Photograph 31 – General view of the LHS wing wall.

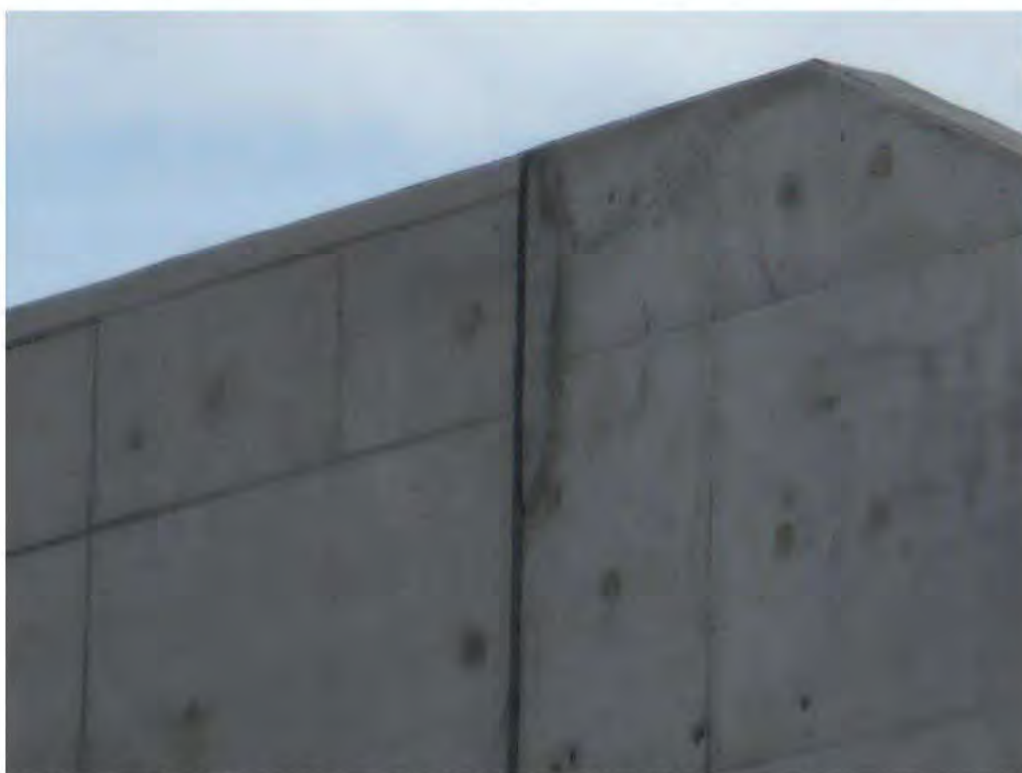
Work, Health & Safety issues noted	Safe access for inspection of the downstream face of the concrete walls of Labyrinth weir	There is no safe access (Photograph 10 and Photograph 31). Therefore, consideration should be given to installing handrails on both LHS and RHS wingwalls as shown in above photographs.
	Ladder access to operate outlet valves	The existing arrangement of ladders and installation of the "recovery system" should be reviewed.
	Ladder on the outside face of the RHS wall	There are several sharp edges the risk of injury to personnel. Consideration should be given to grinding those sharp edges to eliminate this risk (Photograph 14).
	The hatch of the outlet valve chamber	The gate latch for the outlet valve chamber is heavy, jammed and hard to open (Photograph 15).
General issues	Illumination during night	There are no flood lights or similar for inspection of the weir during the night, in case of an emergency.

There is no safe access to the downstream apron area from left abutment. Therefore, consideration should be given in providing a hand rail as shown in yellow, or similar acceptable arrangement. A close-up view of the defect repaired during the construction stage (Circled in orange) is shown in Photograph 32.
